REVIEW OF THE DCPRA: Letter Report-01/Rev.2

A REVIEW OF SYSTEM'S ANALYSIS IN THE DCPRA:  
THE SOLID STATE PROTECTION AND  
REACTOR PROTECTION SYSTEMS

May 1989

Risk Evaluation Group  
Department of Nuclear Energy  
Brookhaven National Laboratory  
Upton, NY 11973

Figure 3.1.a SSPS master fault tree for steam generator tube rupture initiator in DCPRA.

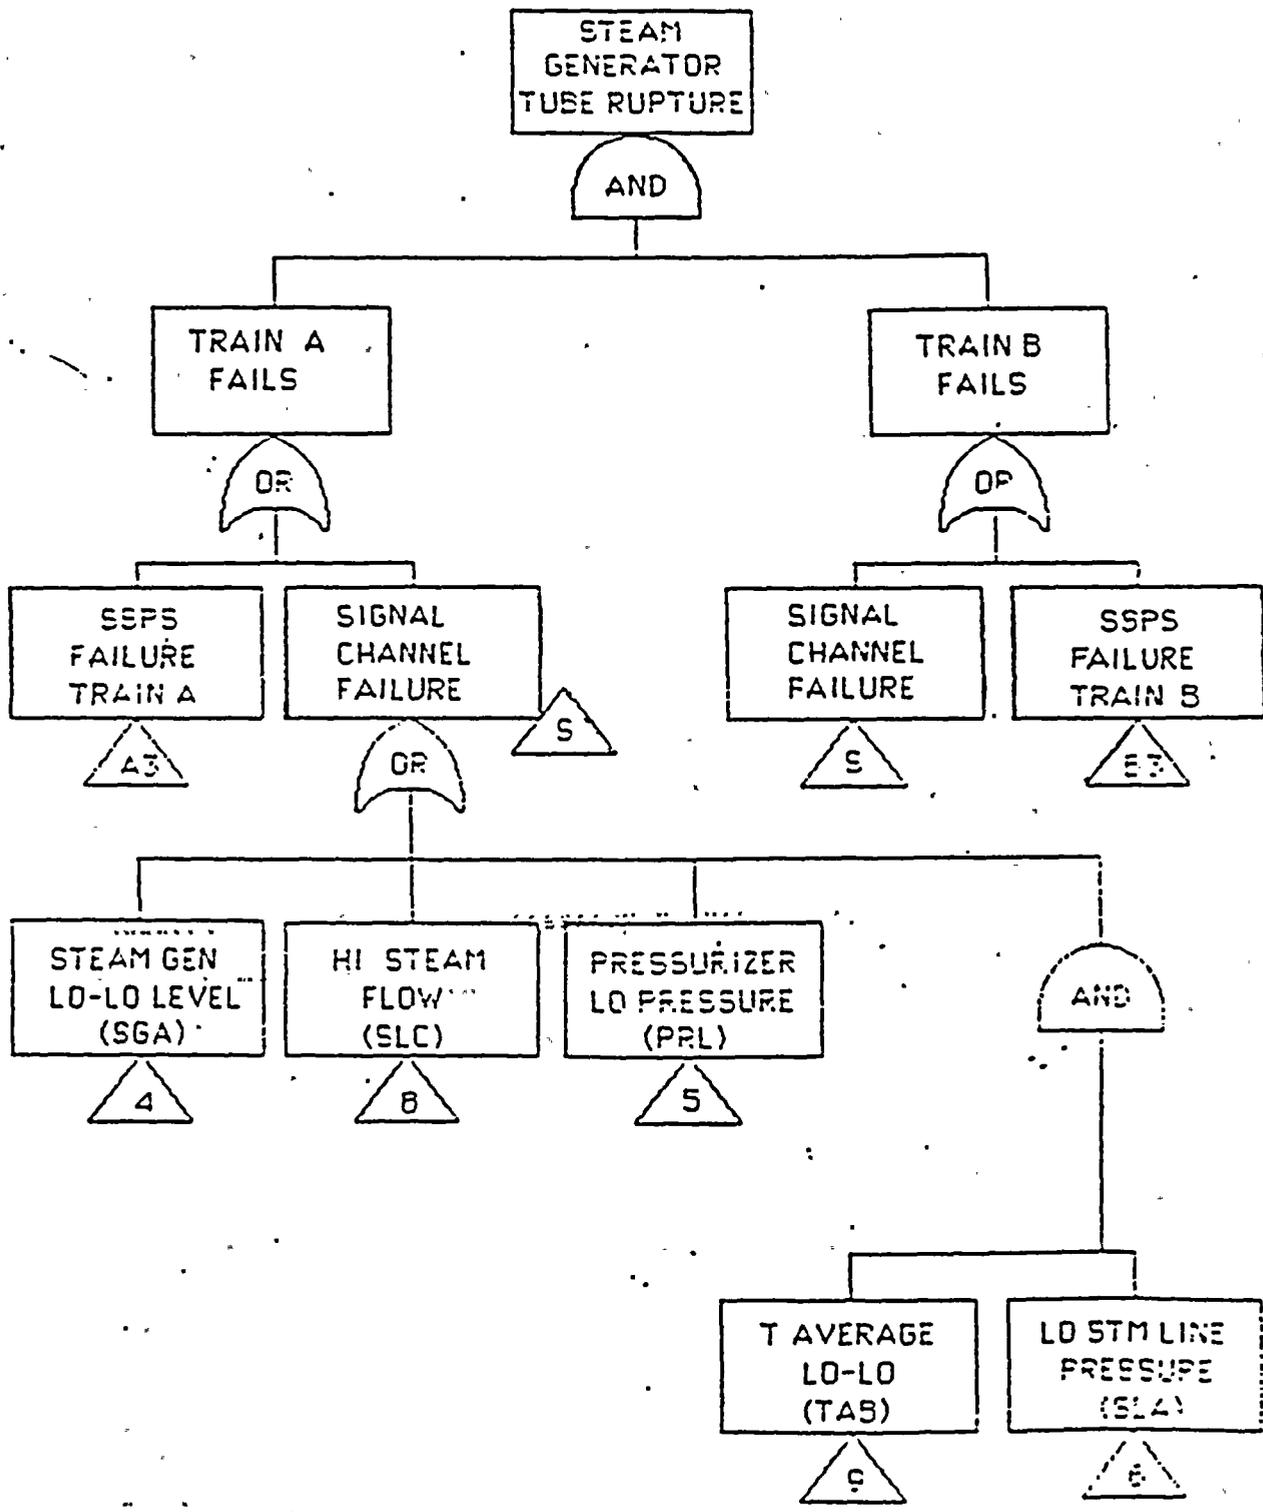
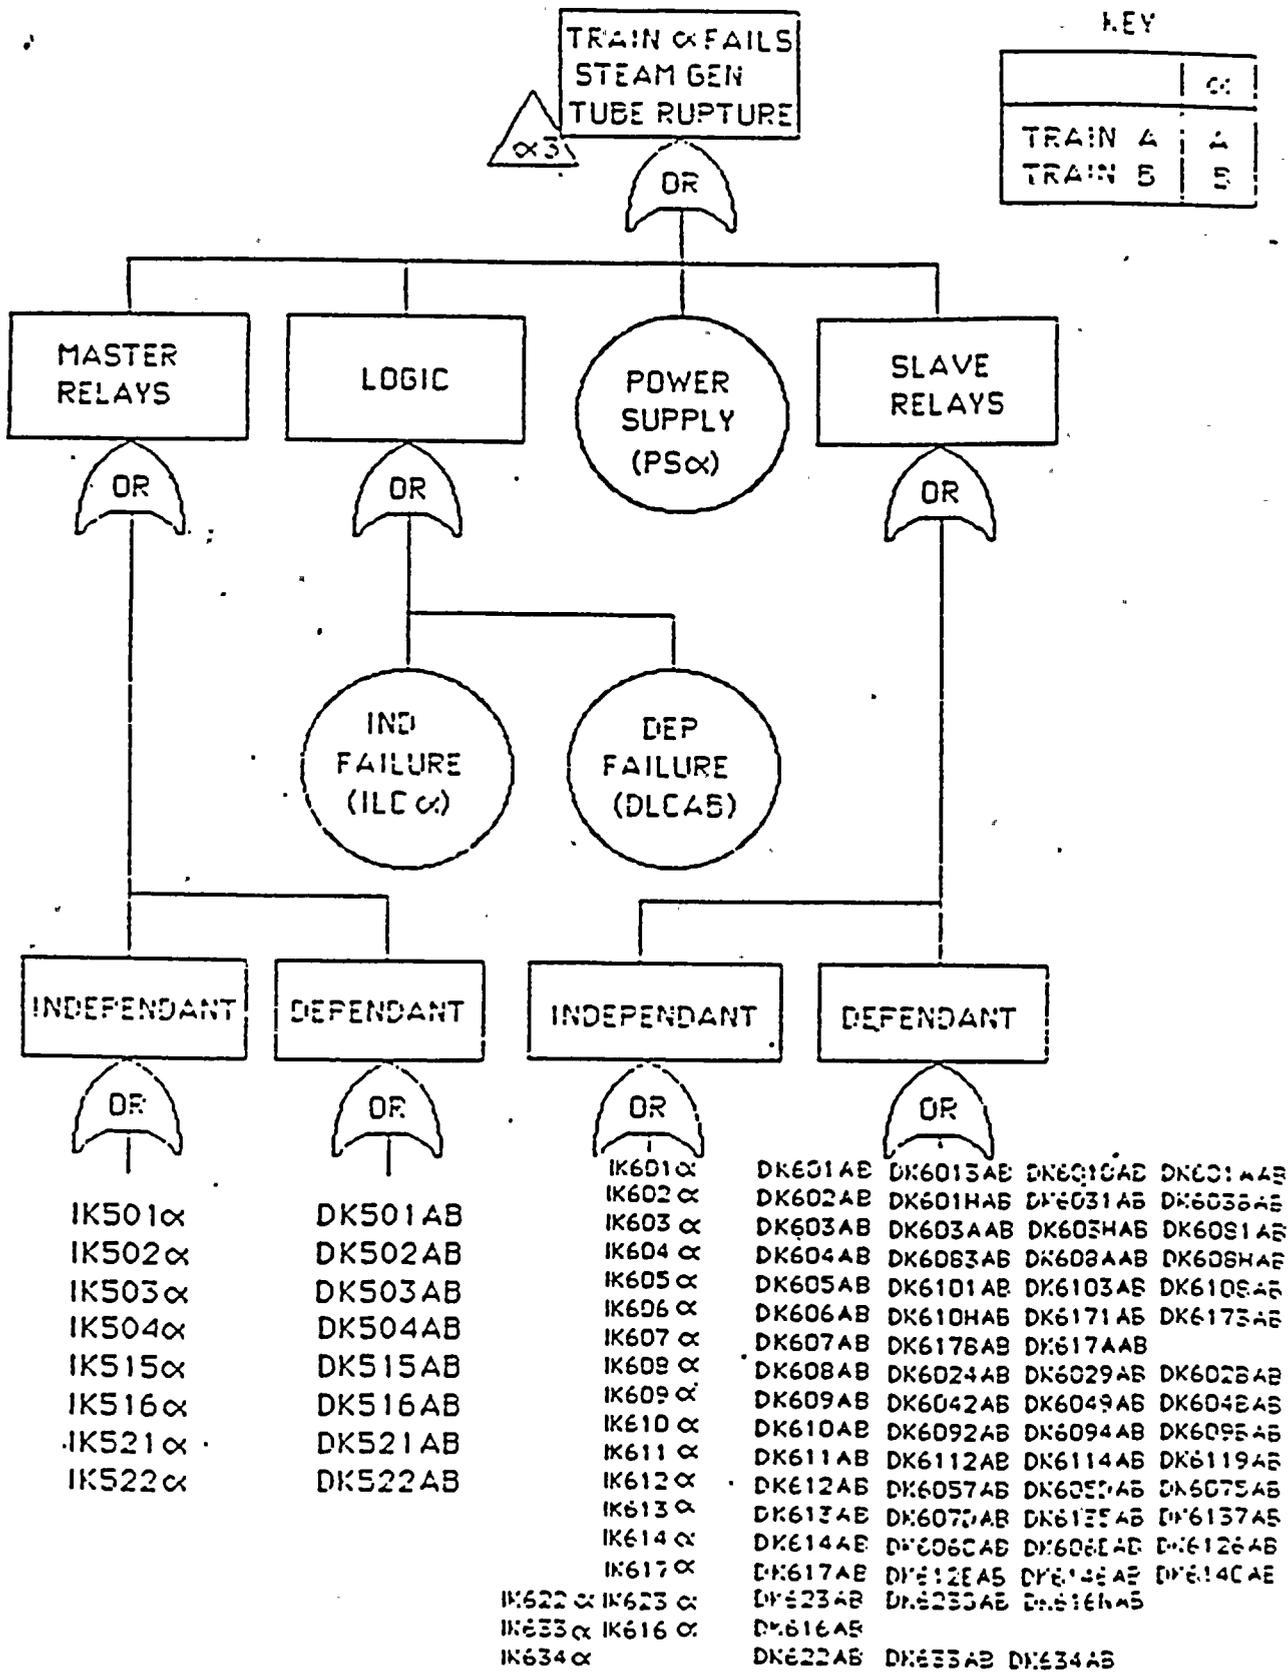
Figure 3.1 shows, as an example, the master fault tree for a class of initiating events: steam generator tube rupture. Given this initiator, the model assumes a diversity of parameter signal failures which may contribute to the failure of an SSPS train (see the SSPS block diagram on Figure 2.4). These are: Pressurizer Low Pressure (2/4), Steam Generator Low-Low Level (2/3 on 2/4

contains a factor of about 4.6, however the situation is exacerbated by the fact that the DCPRA gives the unavailability for a group of safety function signals (i.e., an OR gate) while the WOG1/BNL1 results relate to the unavailability of a single safety function signal alone. In other words, a direct comparison would yield a larger discrepancy.

BNL believes the root cause of the discrepancy is that an oversimplified fault tree model was used for the SSPS in the DCPRA and plans to substitute what is believed to be more appropriate results (BNL/WOG) in any BNL requantification (modified as necessary to reflect the conditional nature of the probabilities required in the DCPRA model) pending any further information from PG&E.

Figure 4.2 RPS fault tree with common cause identified in DCPRA.

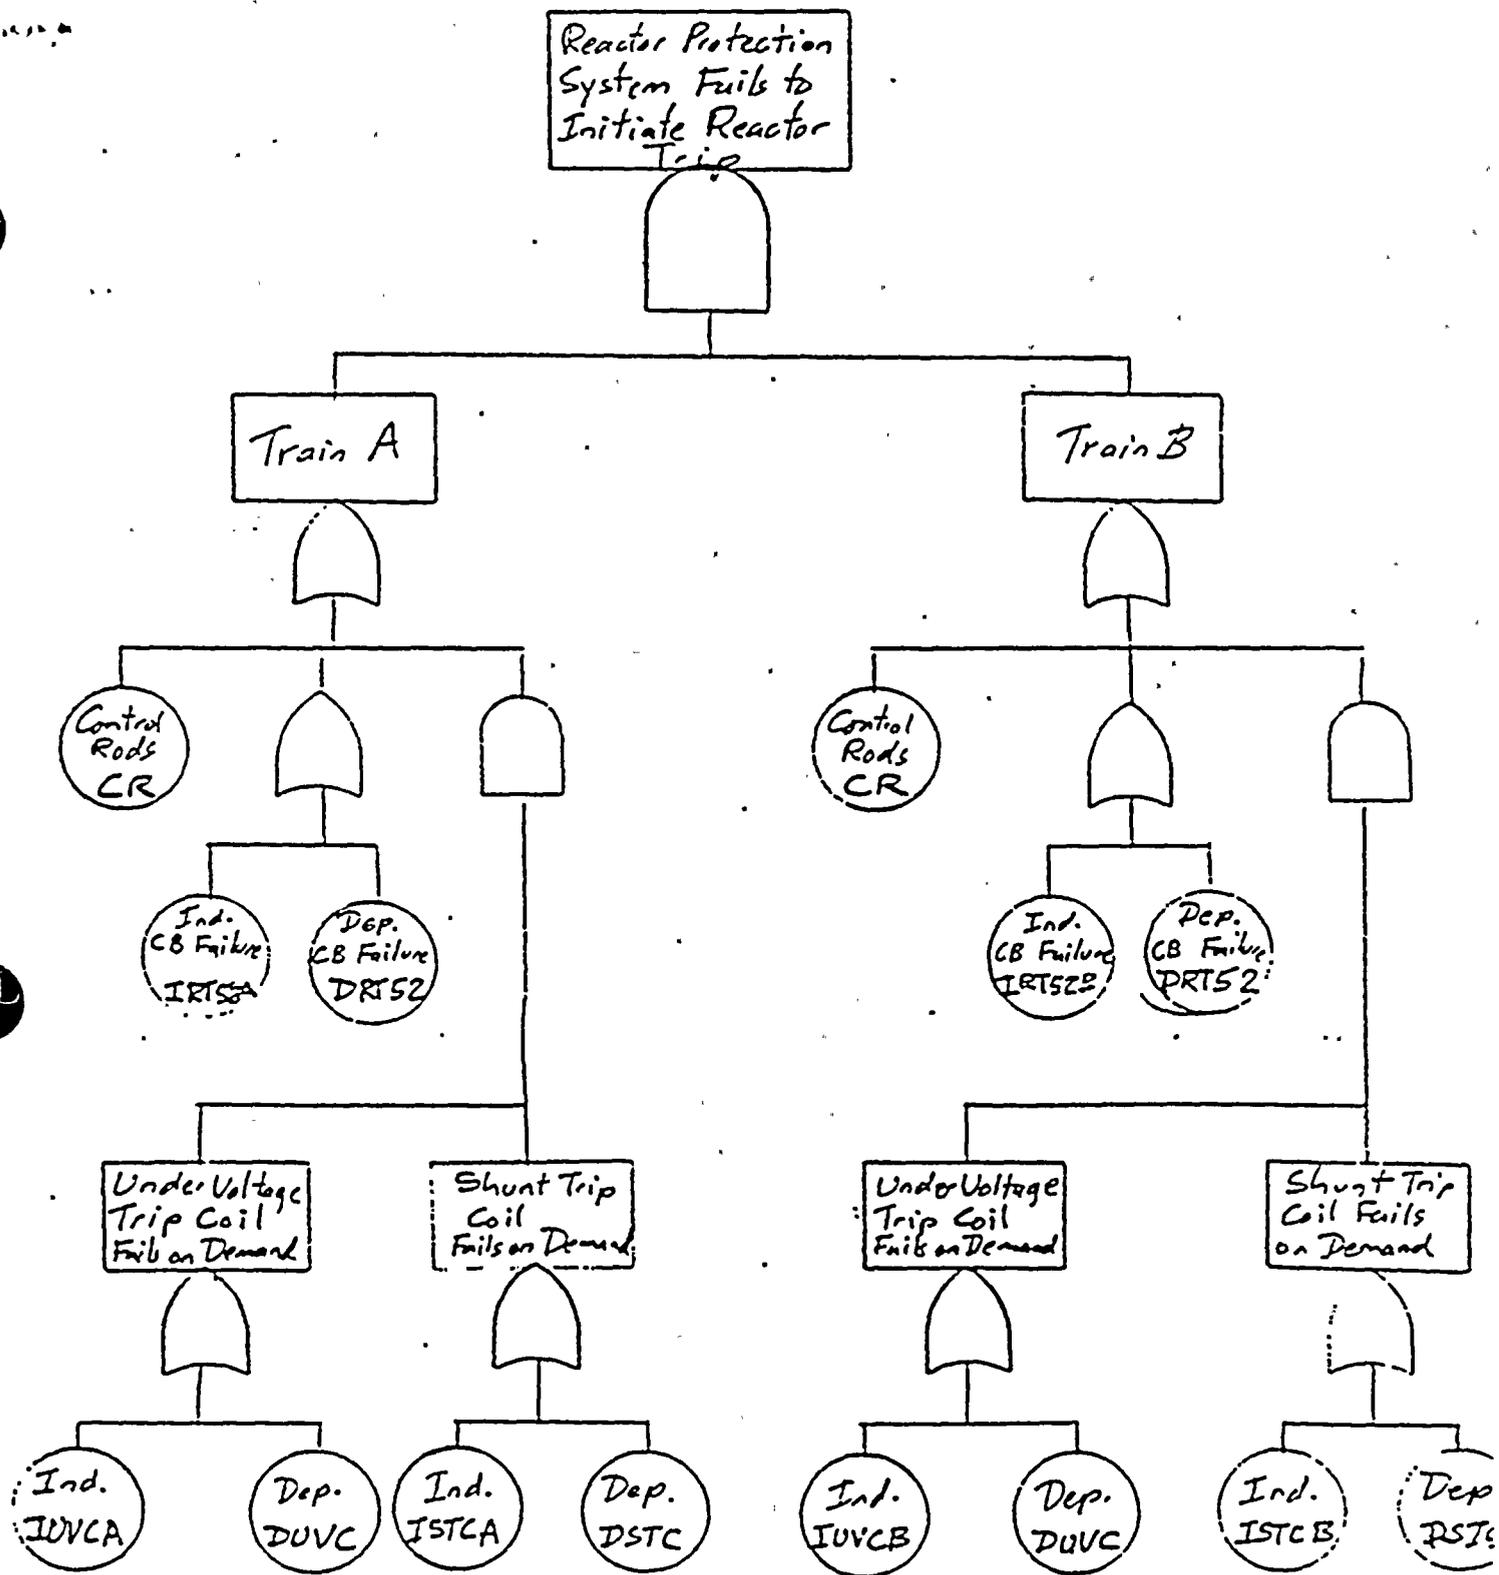
The RPS fault tree model of the DCPRA is shown in Figure 4.2. It is a block level fault tree with identified common cause events ( $\alpha$ -factor model). The block events involve the control rod insertion failure, circuit breaker

The surveillance and maintenance conditions of the RPS modelled in the DCPRA are shown in Table 4.1. The model correctly describes the staggered testing of the trip breakers. The effect of loss of dc power, instrument ac and loss of SSPS signals are considered in the boundary conditions. The quantification indicated that the common cause failures of the circuit breakers and trip coils dominate the system unavailability.

The results obtained in the DCPRA seem to be somewhat lower than those obtained in the WOG2/BNL2 calculations. Since in the DCPRA calculations the analog channel/logic unavailabilities are not explicitly included (only through the boundary conditions) the obtained conditional unavailability values can be taken as reasonable. Therefore, we do not, at this time, intend to alter the DCPRA split fractions pertaining to the RPS in any BNL requantification.
